WKJ1 - Replacing Fuel Tank Cap (Workshop Campaign)

Vehicle Type: **Cayenne S E-Hybrid (92A)**

Subject: **Fuel tank cap**

Fuel tank cap

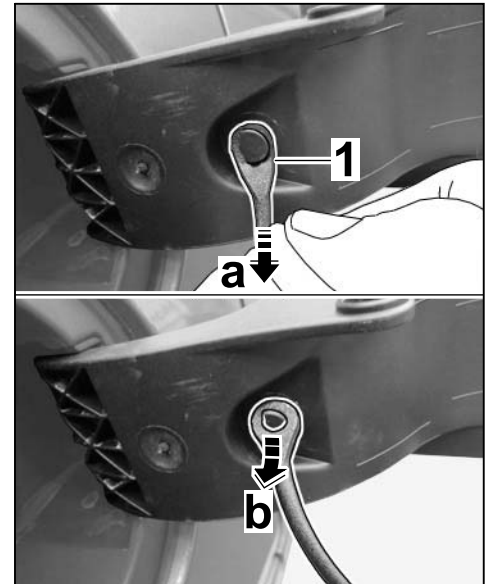
Information: **There is a possibility that the sealing ring on the fuel tank cap will be pressed out of the sealing seat under certain conditions on the affected vehicles.**

If this happens, fuel vapor can escape from the fuel tank. The customer may get a smell of fuel and might hear a hissing noise in the fuel tank cap area.

Remedial Action: Replace fuel tank cap.

Work Procedure: 1 Replace fuel tank cap ⇒ *Fuel tank cap-1-*.

1.1 Open the filler flap.

Removing retaining strap for fuel tank cap

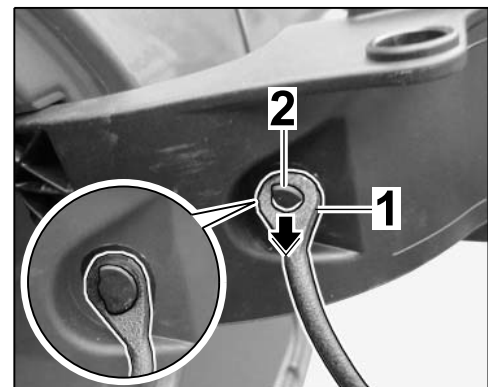
- 1.2 Carefully pull the retaining strap ⇒ *Removing retaining strap for fuel tank cap -1-* down ⇒ *Removing retaining strap for fuel tank cap -arrow a-* and then guide it up over the retaining pivot ⇒ *Removing retaining strap for fuel tank cap -arrow b-* and remove it.
